TECHNICAL BULLETIN  
Q382NAS1  
03 JUN 2014

Service Action: Front Suspension Lower Control Arm-to-Knuckle Nut

**Range Rover Evoque (LV)**  
**Model Year:** 2014  
**VIN:** EH888926-EH903896

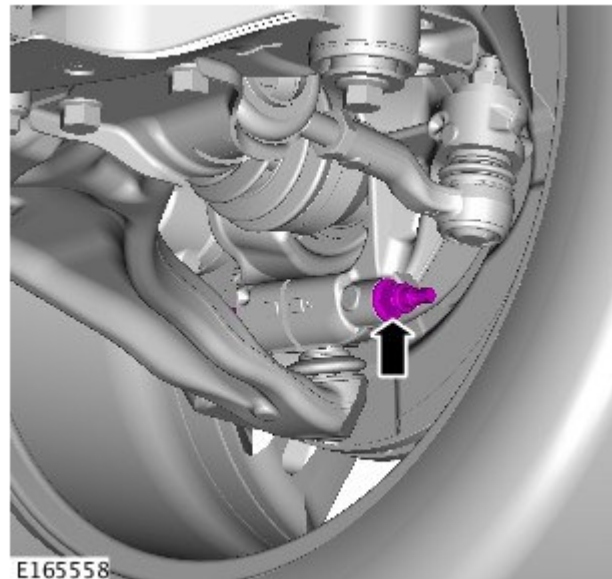
2.  **NOTE: Front right shown; front left similar.**

Torque the front suspension right-hand lower control arm-to-knuckle retaining nut to 175Nm.
